**Comments on the
DRAFT ENVIRONMENTAL ASSESSMENT REPORTS and
POTENTIAL CONDITIONS UNDER THE *CANADIAN ENVIRONMENTAL
ASSESSMENT ACT, 2012* for the
BHP CANADA,
CENTRAL RIDGE, and
WEST FLEMIST PASS
EXPLORATION DRILLING PROJECTS**

November 2020

By the NunatuKavut Community Council

Figure 1: Comparing the location of NL offshore exploratory projects with movement of Atlantic salmon smolts.¹³

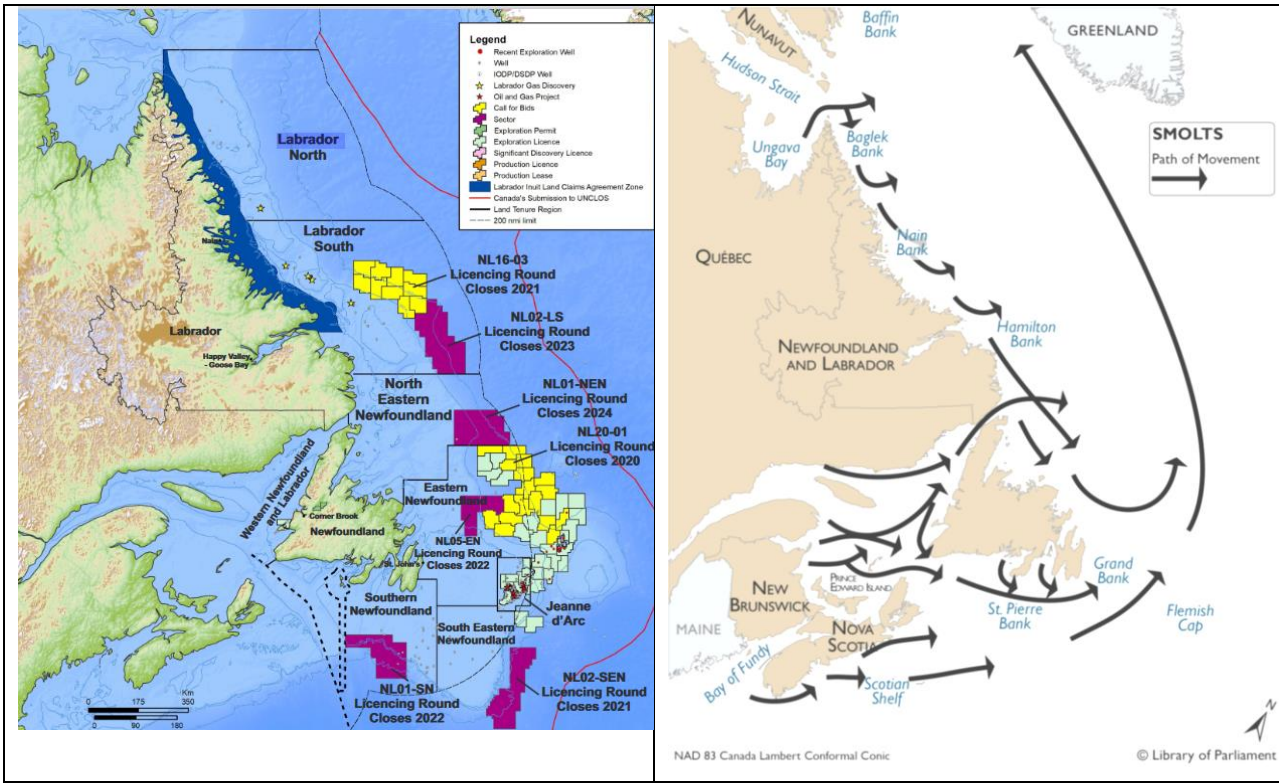
While uncertainty obviously exists, some existing information about salmon migration patterns points to the fact that young salmon leaving natal rivers on the coast of southern Labrador often follow the flow of currents heading south, en route to feeding and overwintering grounds. In so doing, they pass rather directly through offshore development areas in the Orphan Basin and West Flemish Pass, as shown in **Figure 1**, below. Information on smolt movements are referred to in the BHP Canada EIS and West Flemish EIS, along with a map, reproduced on the right side of Figure 1.

As the ocean waters warm due to climate change, NCC is concerned that salmon migration patterns could be affected by water temperature changes. As noted by BHP Canada, “changes in environmental conditions can spatially alter typical distributions and migration routes as well as marine survival” (references omitted).¹⁵ To its credit, the BHP Canada has also acknowledged the existence of “evidence of possible climate-induced salmon prey population changes that may be actively changing salmon distributions within the North Atlantic Ocean over time” (references omitted).¹⁶
